ADDRESS : 376 TACTICAL DR
CONTRACTOR : GARY ROBINSON HOMES LLC
OWNER : 210 HIGHWAY DEVELOPMENT LLC
PARCEL : 01-0547- - 0024- -28-
APPL NUMBER: 13-50030353 CP NEW RESIDENTIAL (SFD)

STRUCTURE: 000 000 50X46 3BDR 2.5BATH SFD W GAR DECK CRAWL

TYP/SQ	REQUESTED COMPLETED	INSP RESULT	DESCRIPTION RESULTS/COMMENTS
R425 03	4/08/13 <u>4-8-13</u>	TI <u>DAJH</u>	FOUR TRADE ROUGH IN TIME: 17:00 VRU #: 002362481 T/S: 04/05/2013 01:26 PM DJOHNSON

Job J0113-0555	Truss F7X	Truss Type FLOOR TRUSS	Qty 3	Ply 1	Lot 26 Gwen Oaks / Hamett Co E6805137
-------------------	--------------	---------------------------	----------	----------	--

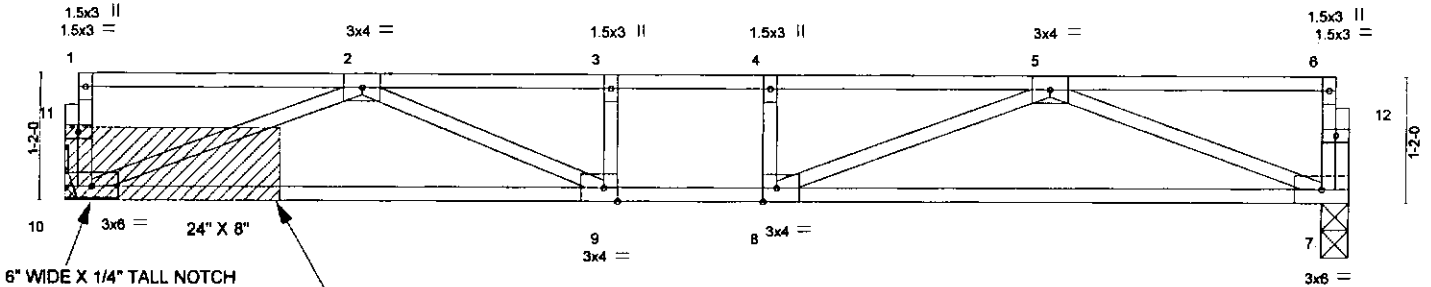
No sheetrock in house @ roughin inspection, PLEASE PLACE SHEETROCK IN THE CENTER OF THE FLOOR FOR INSPECTIONS. Missing anchor bolt on left side of garage & can't inspect the rest of left side for sheetrock. Seal air barriers in garage per code. Seal hole @ wire in air barrier in master bath closet. Can not inspect right wall & front wall of master bedroom for sheetrock. Missing stud on each end of shower. Can not inspect back wall in dining room or left wall in kitchen sheetrock needs to be moved. Repair cut hole in kitchen floor. Need R15 insulation behind fire place, landing for stairs & all air barriers required by code. Can not inspect front wall in living room for sheetrock in way. Need engineer letter for cut floor truss in foyer @ the bottom of the stairs. "STOP INSPECTION ON FIRST FLOOR TO MANY VIOLATIONS"

CUT AND REMOVE SECTION INDICATED BY DARKENED REGION. LUMBER AND CONNECTOR PLATES TO BE CUT CLEANLY AND ACCURATELY AND THE REMAINING PLATE MUST BE FULLY EMBEDDED AND UNDISTURBED.

ATTACH 3/4" PLYWOOD OR OSB GUSSET (23/32" APA RATED SHEATHING 48/24 EXP 1) TO EACH SIDE OF TRUSS WITH CONSTRUCTION QUALITY ADHESIVE AND ONE ROW OF 10d (3" X .131") NAILS SPACED 4" O.C. FROM EACH FACE IN ALL MEMBERS.

GUSSET MAY BE TRIMMED CAREFULLY AND ACCURATELY TO ACCOMMODATE HANGER
